### OFFICE OF THE SPECIAL INSPECTOR GENERAL FOR IRAQ RECONSTRUCTION

# FIRE STATION CONSTRUCTION AINKAWA, IRAQ

SIGIR PA-06-036 April 12, 2006

#### SUBJECT: Report on Project Assessment of the Fire Station Construction, Ainkawa, Iraq (Report Number SIGIR-PA-06-036)

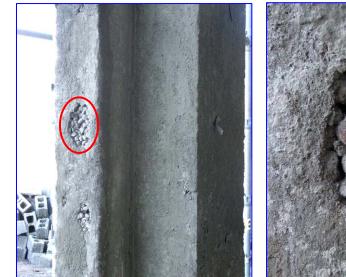
The task order specifications for concrete required the use of naturally occurring sand and crushed gravel, uniformly graded. The aggregate utilized in the reinforced concrete shown in Site Photos 5-9 appears to be rounded, uncrushed gravel.
